TREE CONSERVATION REPORT  
ADDENDUM 2.1  
71 Russell Ave

Tree Conservation Report Addendum submitted as  
Partial Requirements for a Site Plan Control  
Application, May 29, 2026

## **Tree Conservation Report Addendum**

Figure 1: Image clip from updated grading plan prepared by TL Mak dated May 27, 2026 showing the walkway curving around tree 1, city owned Norway maple. The distance from the edge of the tree trunk to the edge of the retaining wall is approximately 1.5 m.

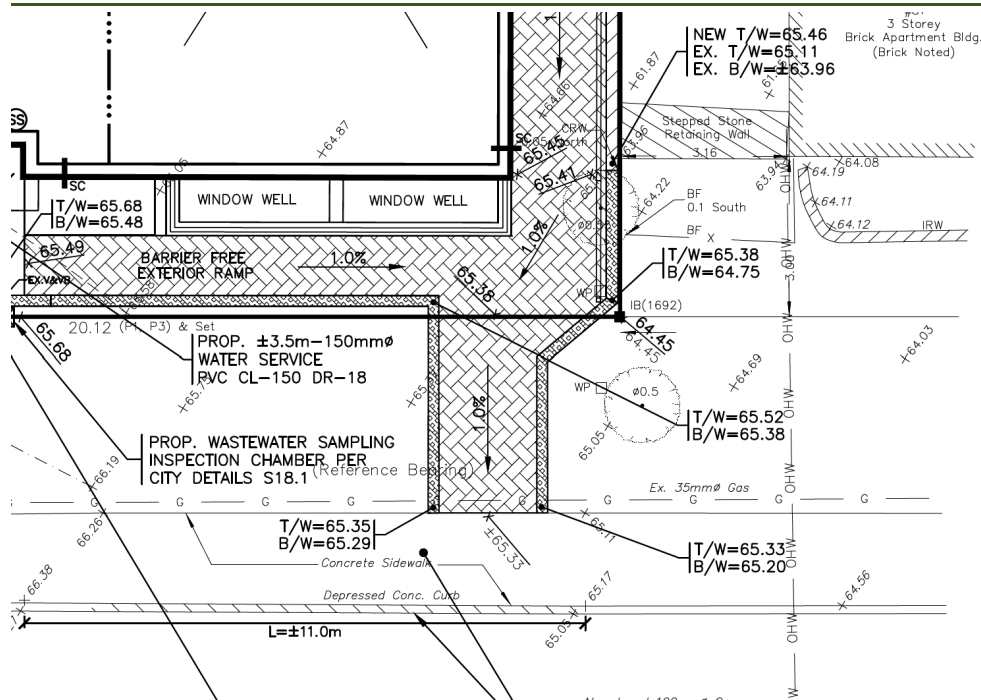
- 1. The retention plan for trees 1, 10 and 11 raises concern. Please provide more detail on the current growing condition of these trees, how much of the CRZs will be impacted by the proposed excavation and how far excavation is from the trunk of each tree. Address how the existing retaining wall beside trees 10 and 11 has influenced root growth and ensure the CRZs of these trees are accurately depicted. For tree 1, the proximity of the pavement and retaining wall is particularly concerning as it appears to be within the trees static root zone. There is concern over trees 1, 10 and 11 being made unstable by the extent of excavation/construction proposed in their proximity.

- 4. The tree protection fencing for trees 10 and 11 overlaps with the proposed stairs and with a future talkway and curb for tree 1. This is unrealistic. Please address in the TCR and provide more details on the plan and how it can be executed as planned.

**Tree 1:** This updated report reflects changes that were made to the grading plan for the walkway to curve around the tree. The new walkway and retaining wall will be approximately 1.5 m from the edge of the tree trunk which should avoid impacting the structural integrity of the tree. The tree roots are to be pruned in advance of any excavation for the walkway and retaining wall and be completed by a certified arborist and/or city forestry staff. The same applies to the removal of any branches for the clearance of equipment on site.
